Village/Town of Mount Kisco Building Department
104 Main Street
Mount Kisco, New York 10549
Ph. (914) 864-0019-fax (914) 864-1085

M E M O R A N D U M

SUBJECT: 40 Grove Barn, LLC– 40 Grove Street
Site Plan Application

DATE: May 5, 2023

Image from DWG SP-3 (7-14-2021 Drawing set). Blue arrows indicate trees which can possibly be saved and for which tree protection should be added.

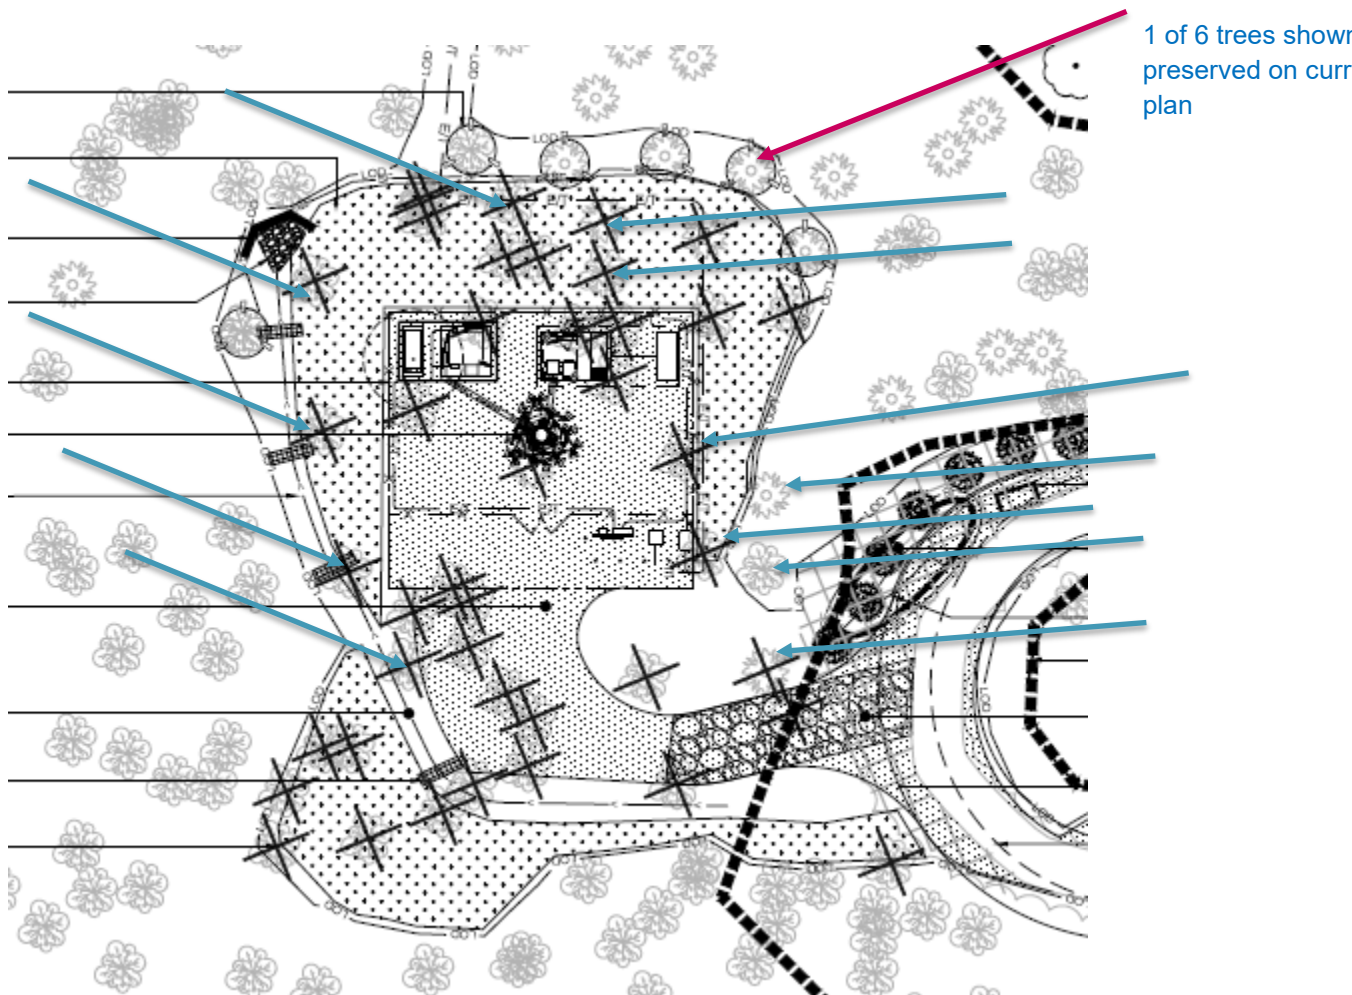
The applicant should verify the number of trees being removed (within the compound / compound access area, and along access road), and reduce if possible, based on even slight re-configuring of the final tower location and compound size / orientation and adjustment of grading, underground utility trenching, and drainage measures (some noted to be temporary for construction).

It is recommended that additional trees be shown as preserved on this and other Site Plan Drawings, including the “key” ones located on the eastern side of the proposed tower / compound location that were noted during the site walks, and along the west side of the proposed compound (see blue arrows in above image). Simulation showing “key” trees on the eastern side of the tower is included below:

SP-2

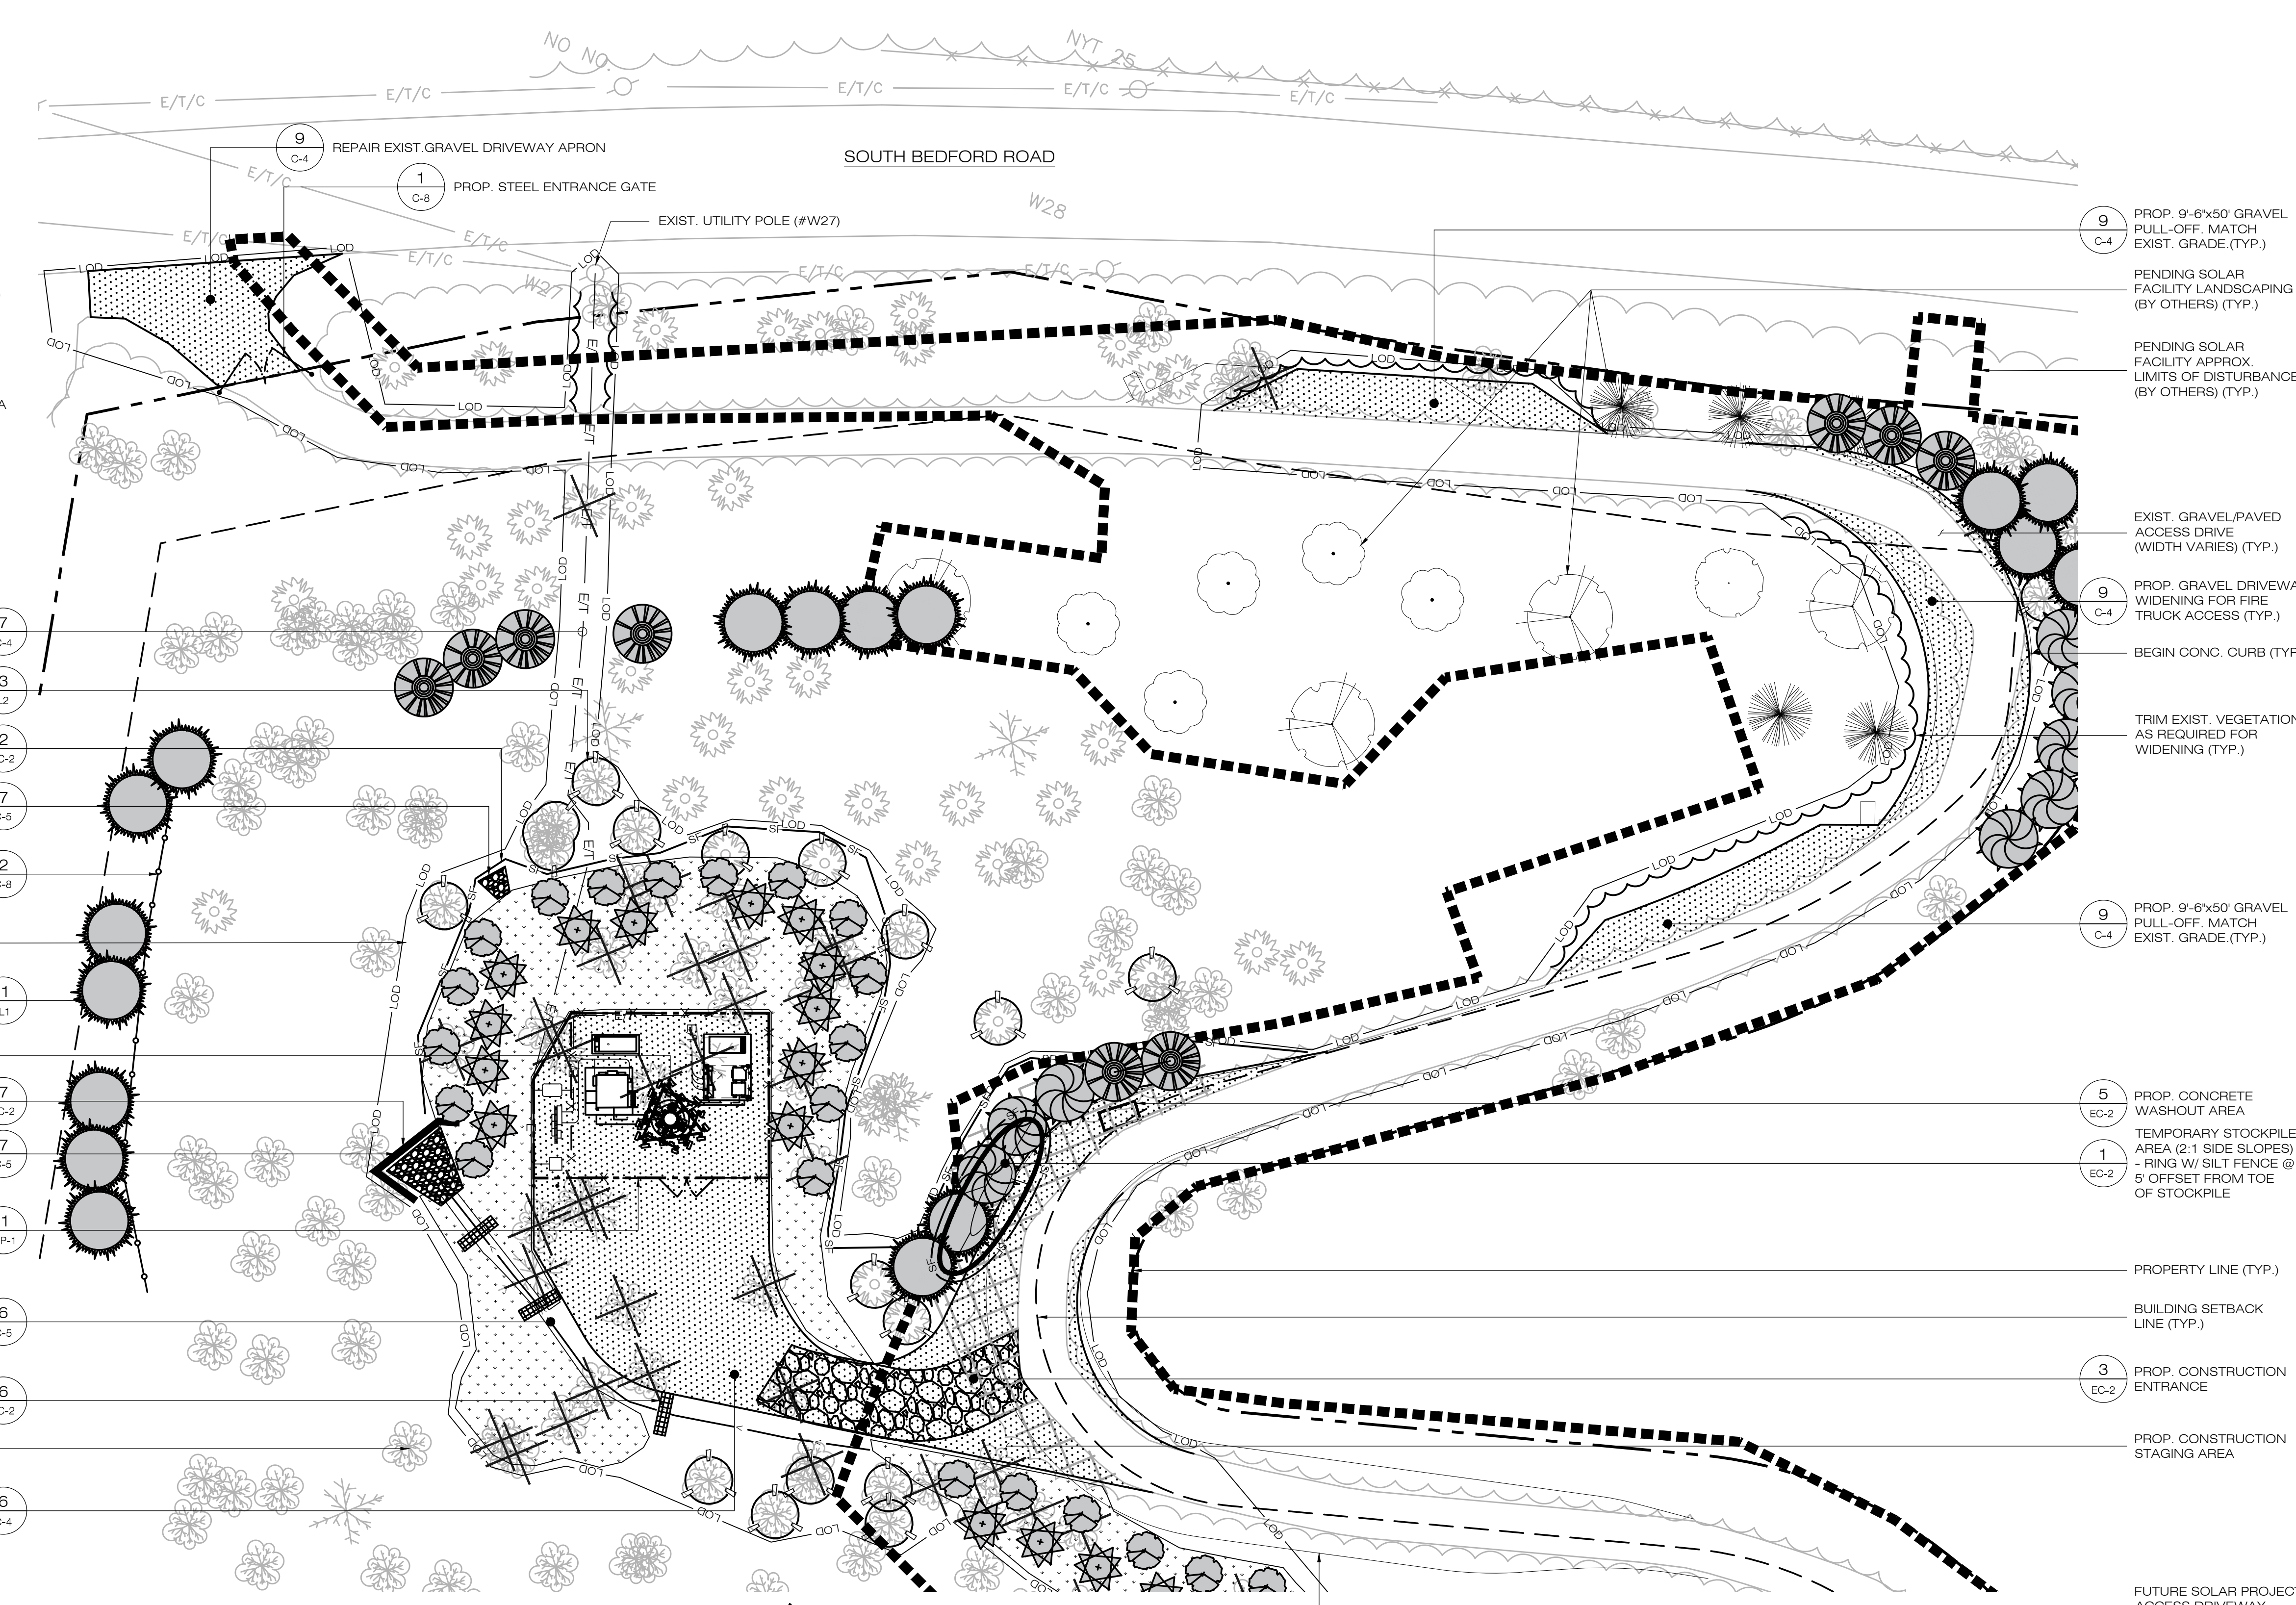
- The Site Plan Drawings indicate that these trees were established conditionally for the solar project in which case they should be shown in red on the revised Site Plan Drawings. The “Limits of Disturbance” in this area (black dashed line in above image) should also be confirmed for the Homeland project; if LOD is specific to the solar project, it should be shown in red print/text on the revised Drawings.
All elements of the proposed design that are associated with the Solar project have been shown in red on Drawings SP-1 and SP-2 on the revised Drawing set. These items are wholly unrelated to and independent from the proposed facility.

All elements of the proposed design that are associated with the proposed Solar project have been shown in red on Drawings SP-1 and SP-2 on the revised Drawing set.
